Service Bulletin

RRP Service Bulletin No: RRP SB248

Title: Hydraulic Oil Cooler Thermostatic Switch Replacement (RRP #466296).

Hydraulic Reservoir Mounted Cooler

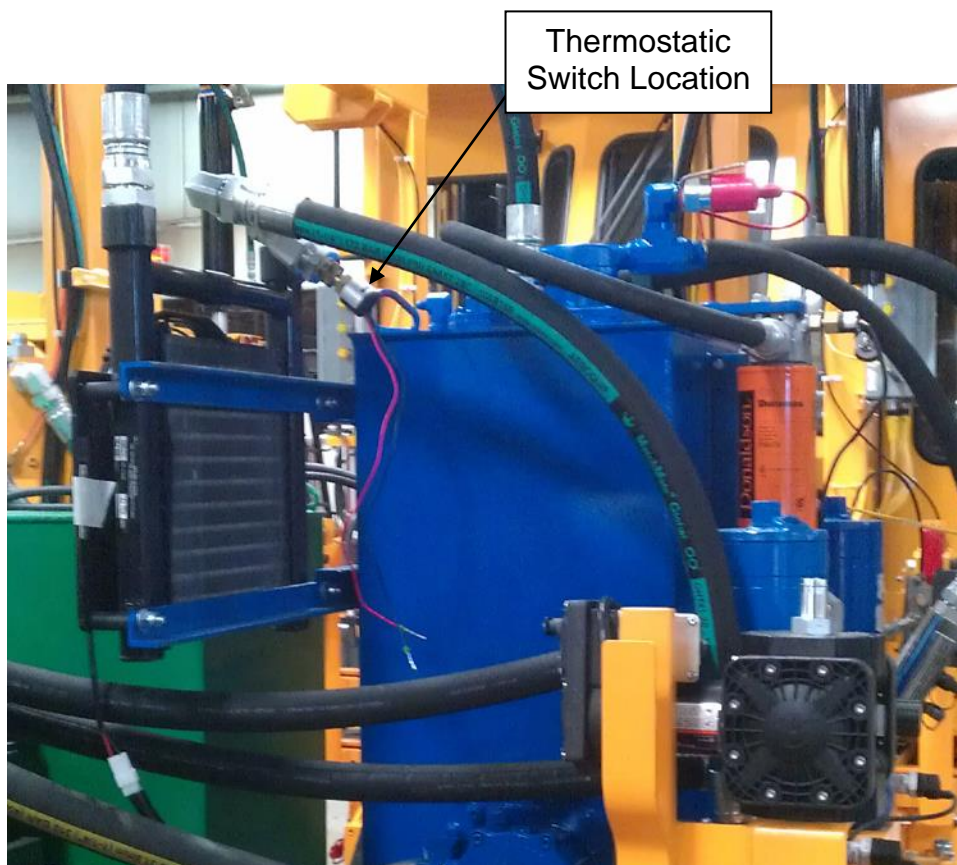
Summary: The thermostatic switch for operating the oil cooler fan has been revised to a lower temperature setting, improving cooler performance.

The old switch (RRP #466296) was set to 140° F. The new switch (using the same number RRP #466296) is set to 110° F.

Action: Disconnect and remove thermostatic switch, install and connect replacement.
